**STAFF REPORT: 06/11/2025 MEETING**

**ADDRESS: 2018 11<sup>th</sup> STREET**

**APPLICATION NO: HDC2025-00250**

**SCOPE: INSTALL BRICK VENEER AT FOUNDATION, PAINT PORCH, REPLACE PORCH SPINDLES, LANDSCAPING**

**Current appearance. Photo taken by HDC staff on 5/25/2025**

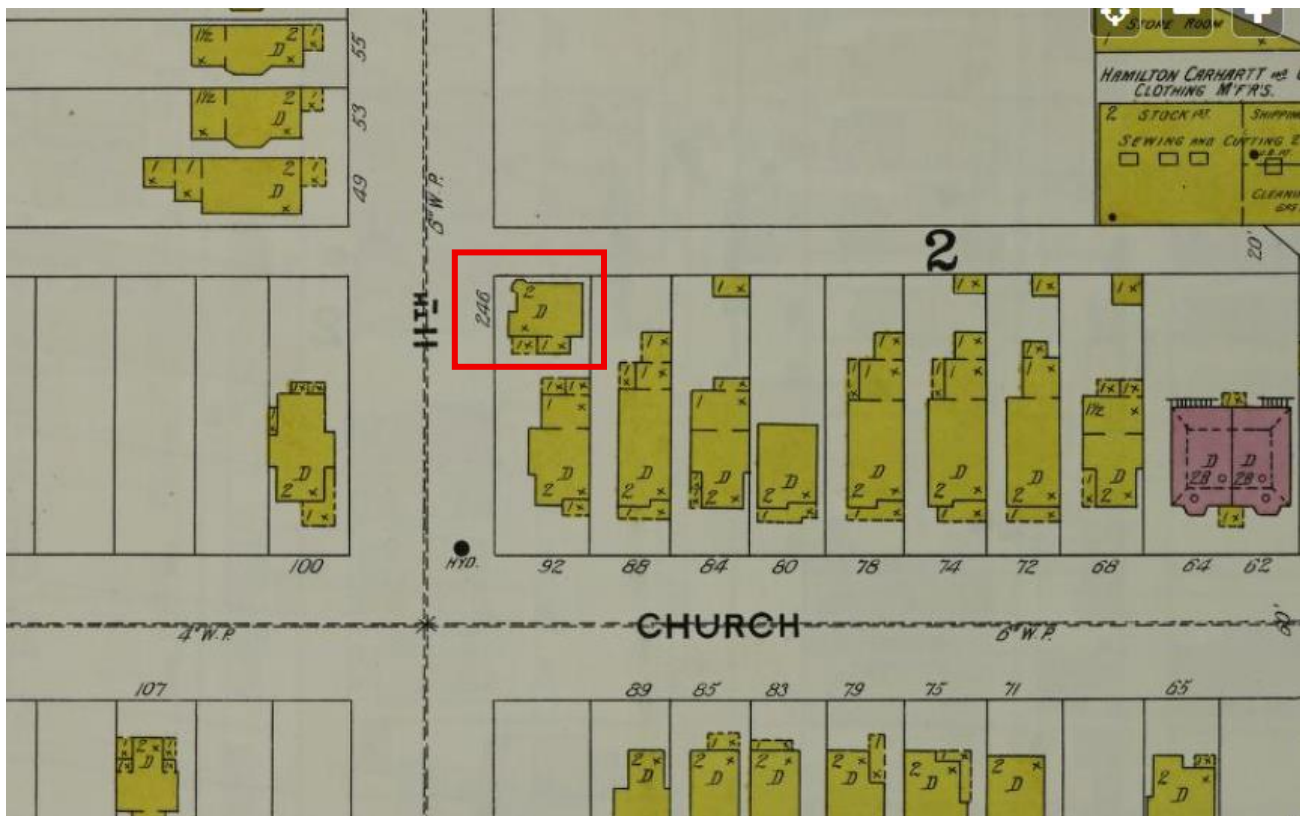
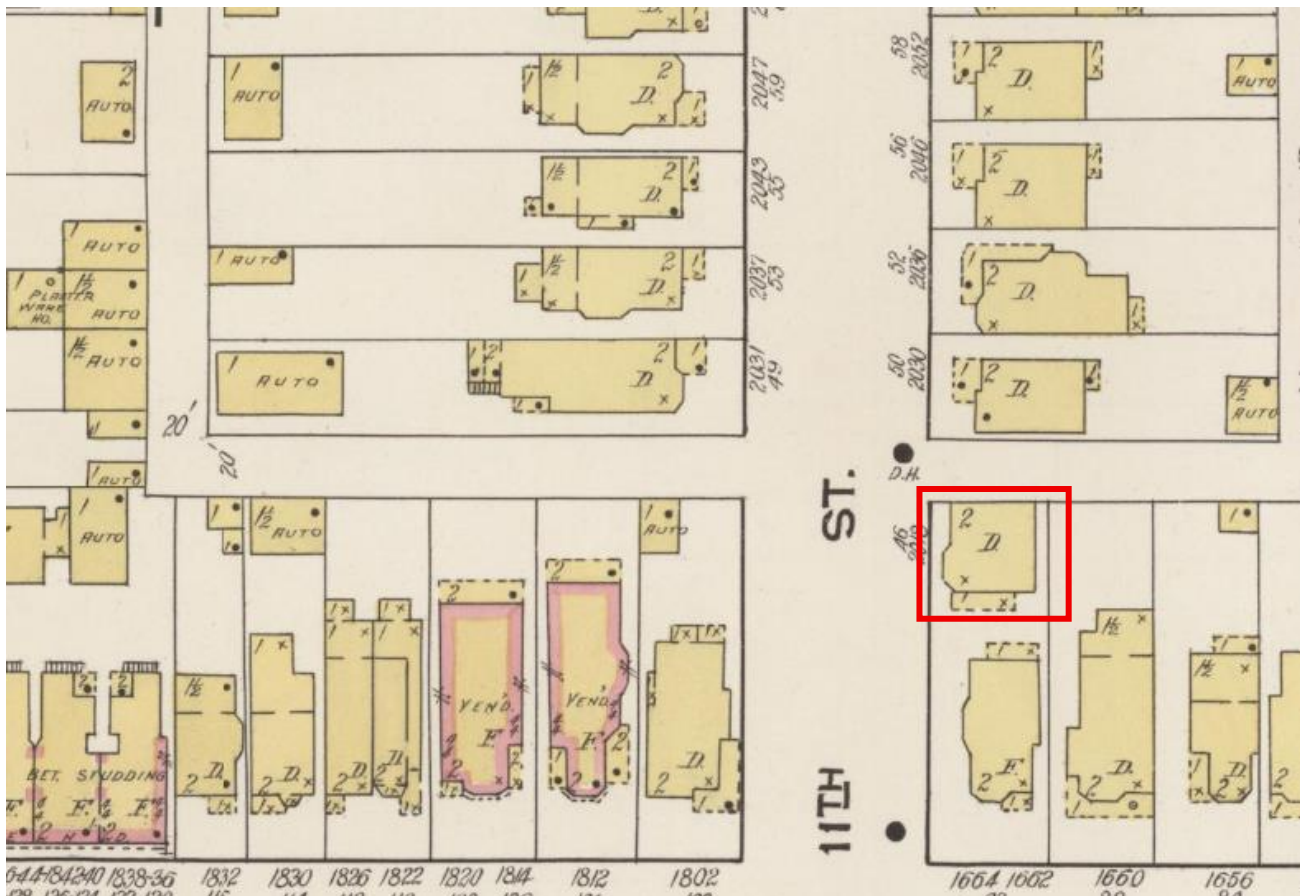
Erected ca. 1890, the building at 2018 11<sup>th</sup> Street is a 2-story, single-family dwelling. The building features a two-story, hipped-roof central mass with pyramidal roof turrets at the northwest and southwest corners. Exterior walls are clad with vinyl and the concrete block foundation wall has been painted grey. Windows are vinyl, 1/1 units. A partial-width, shed-roof porch at the building's south facade displays turned wood columns with decorative, jigsawn, wood brackets, wood flooring and stairs, and tall ahistorical wood handrails with square balusters. Concrete has been added to the parcel's small front yard area. A metal fence encloses the parcel's side yard.
